ASCHAM ST PARK IMPROVEMENTS

Addendum # 1

April 18, 2022

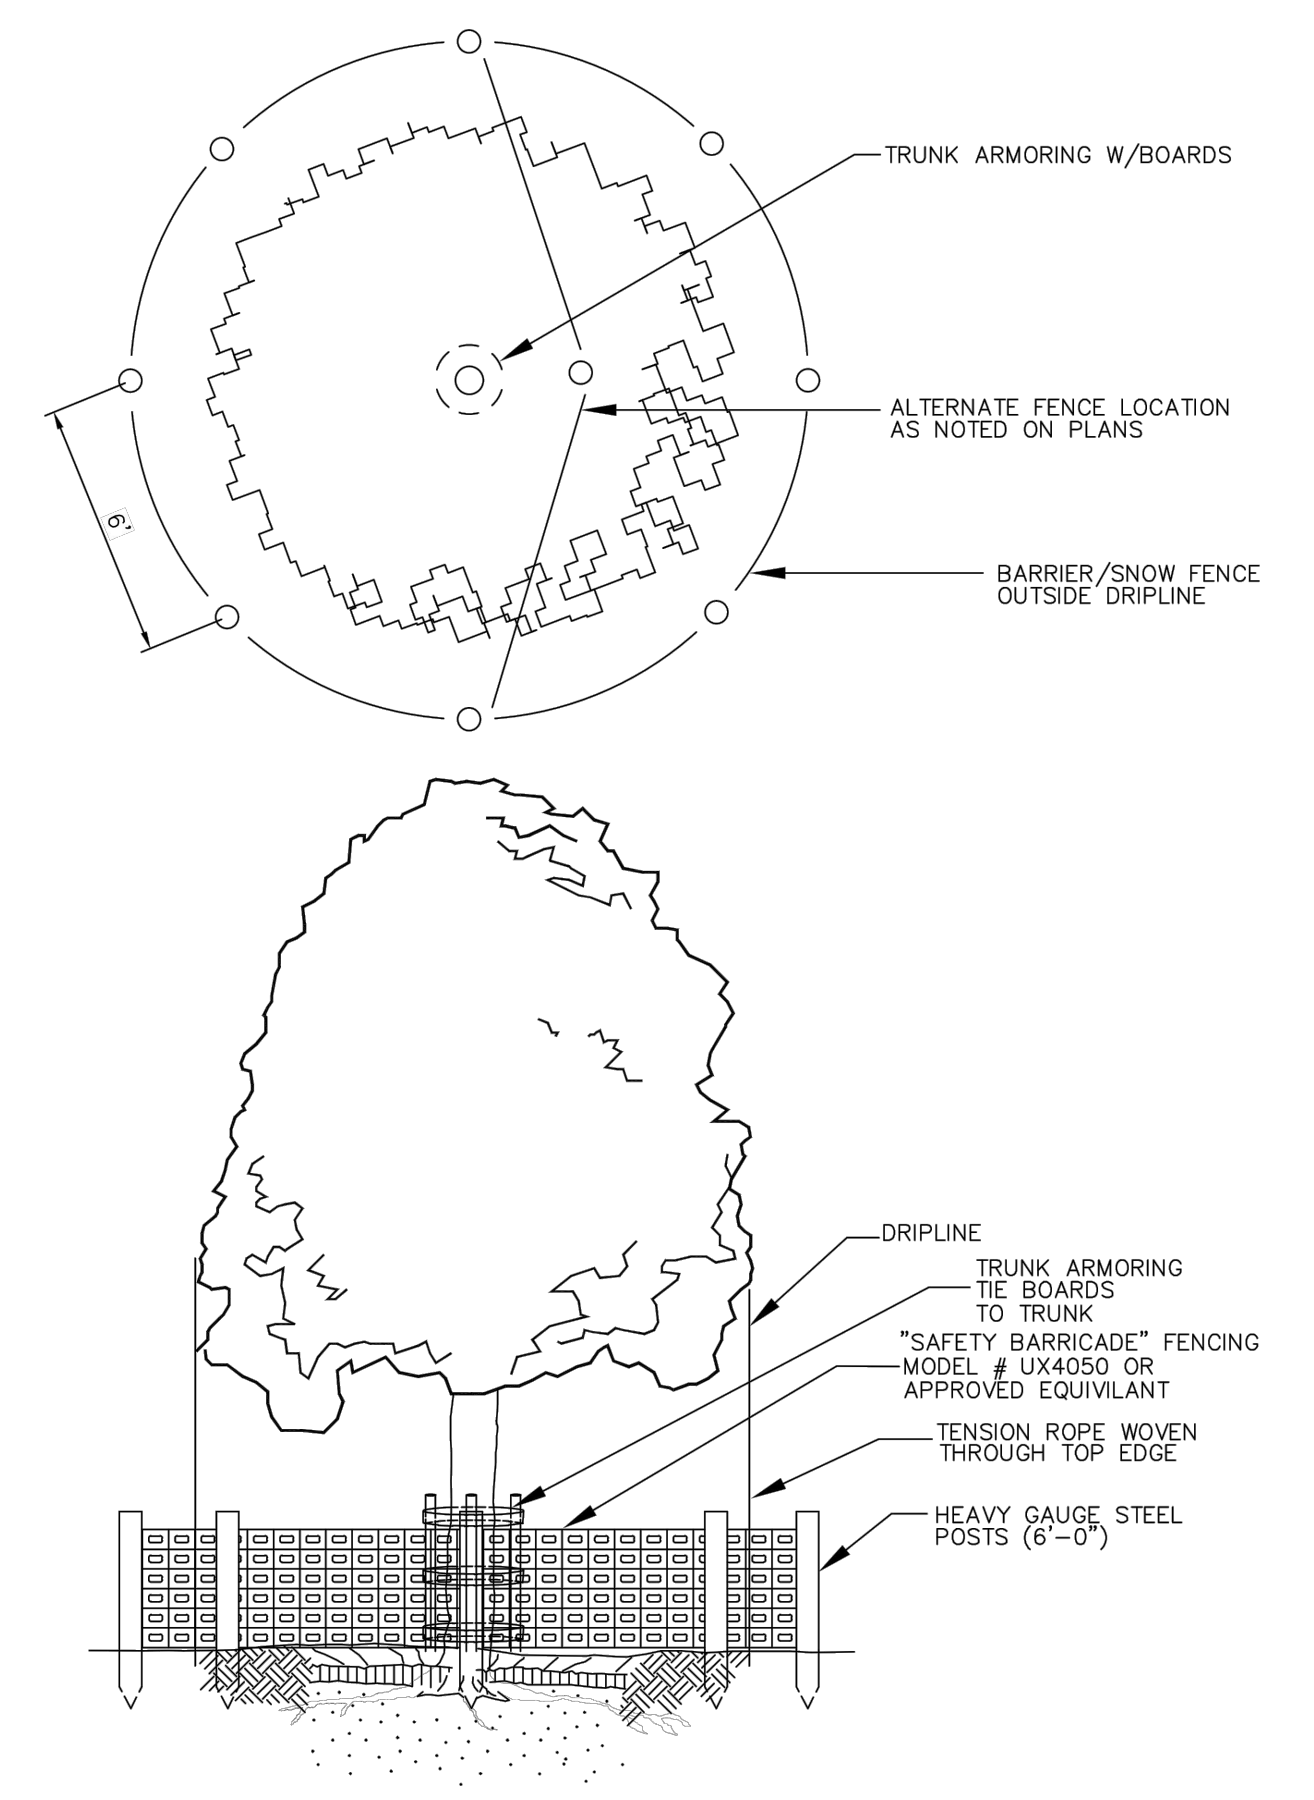
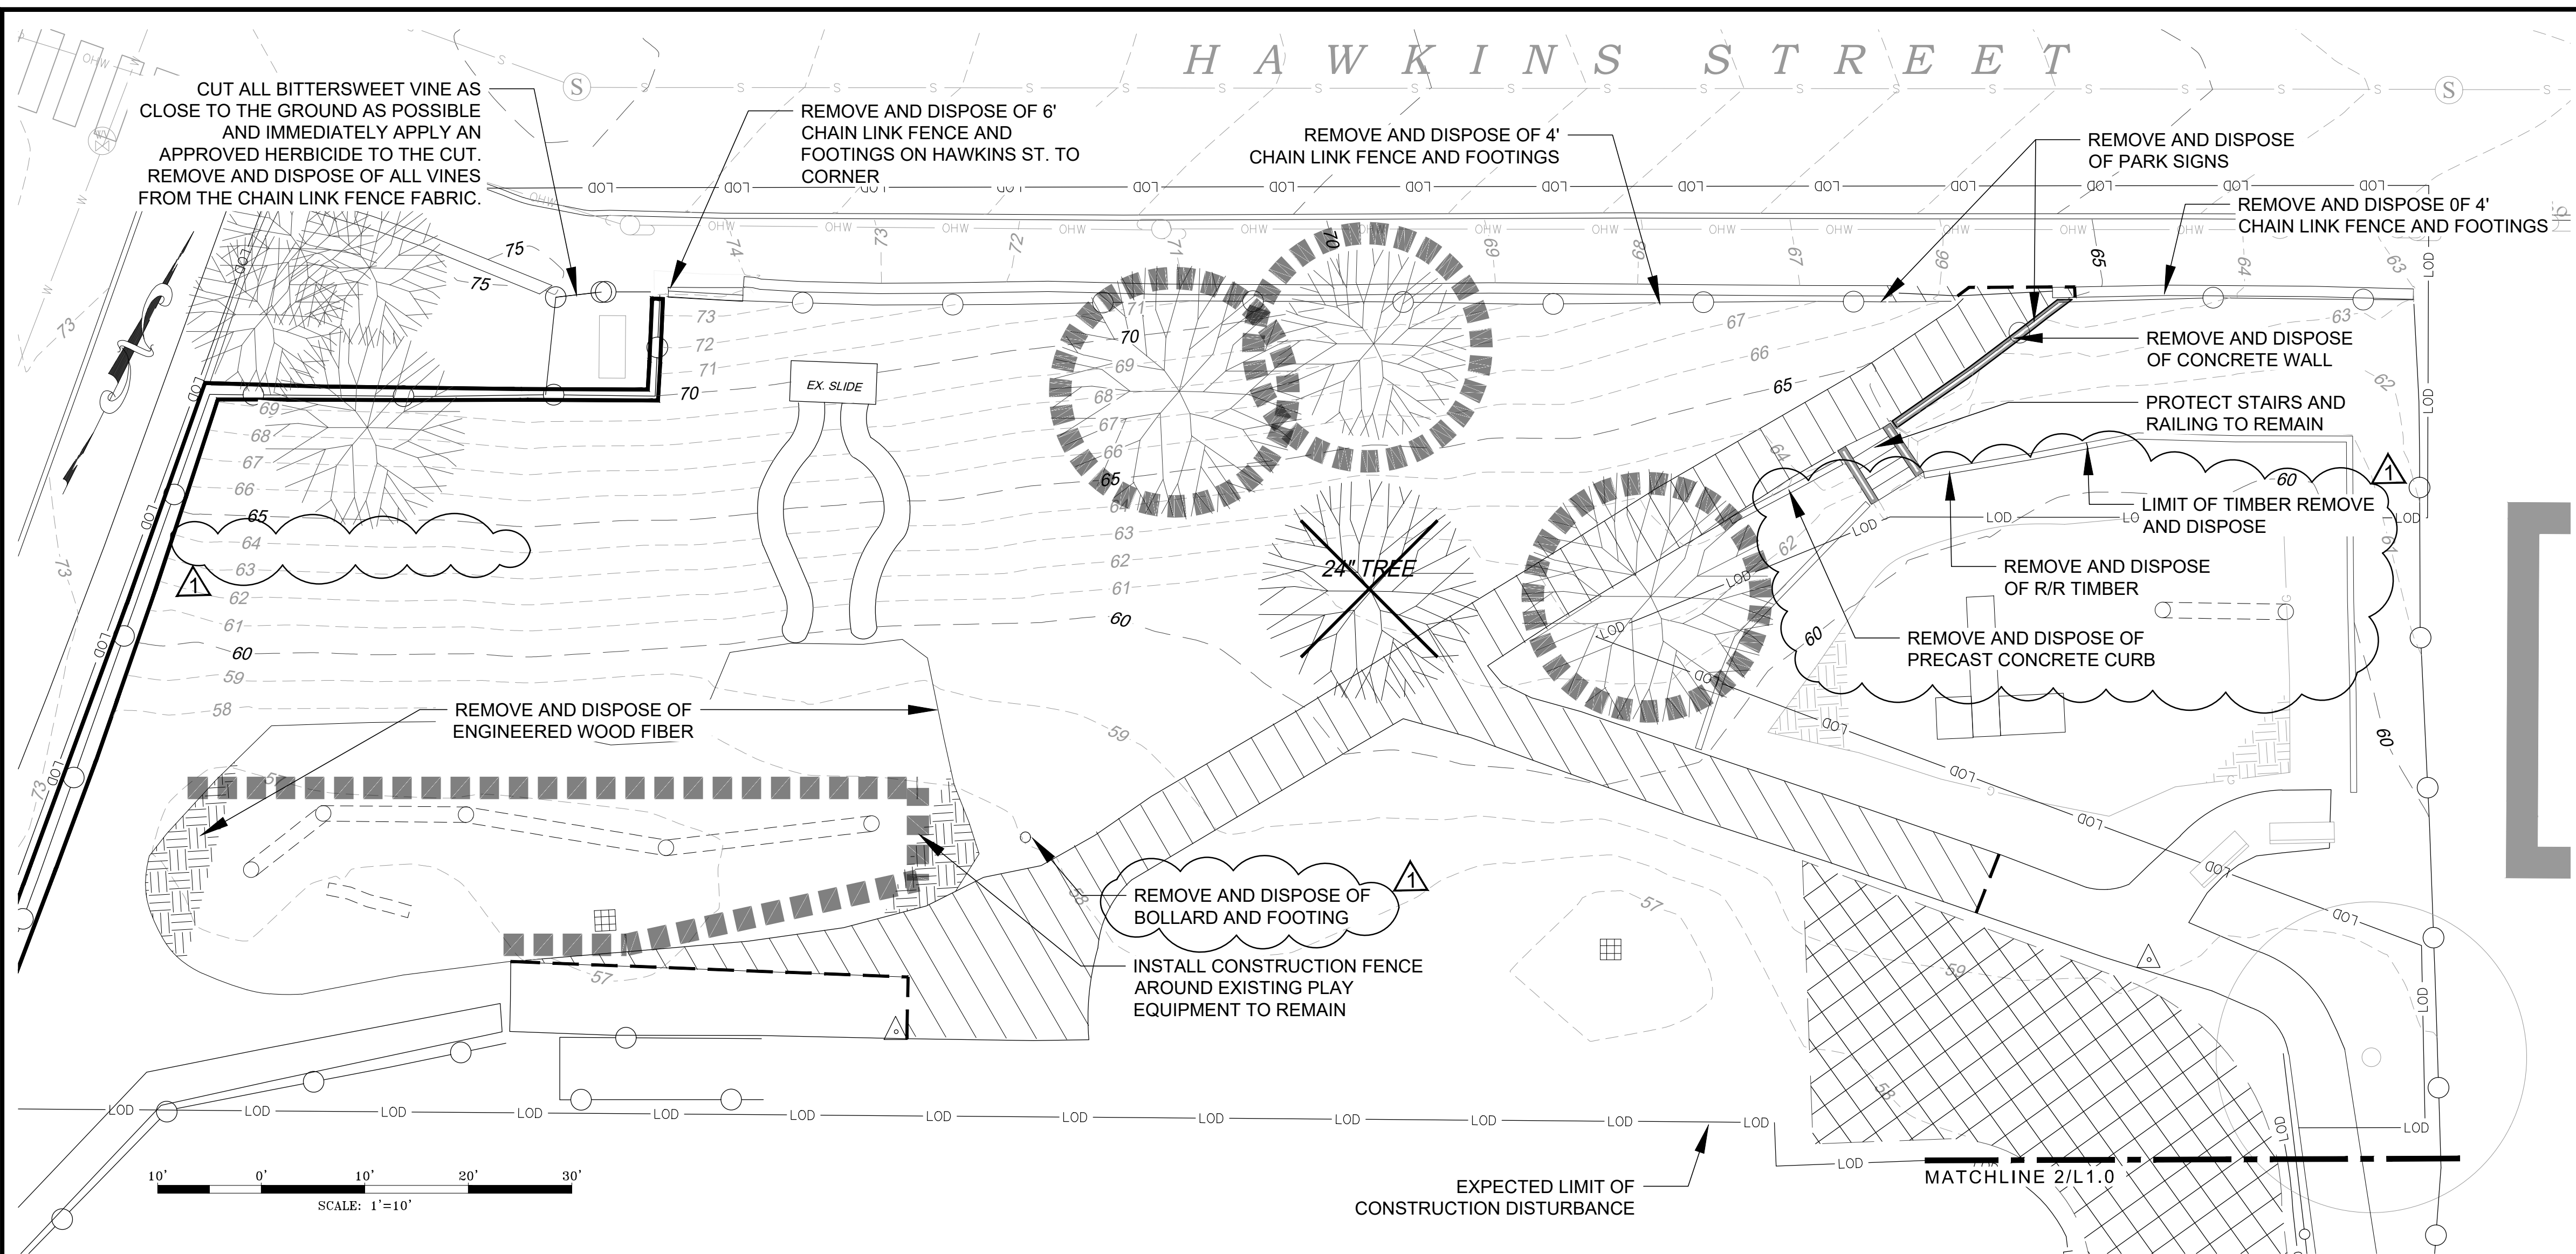
1. The Wooden Bollard/Rope Climb features have been replaced with the Rope Pull from LSI, this will be a custom product from Landscape Structures, please refer to attached drawings and specs.
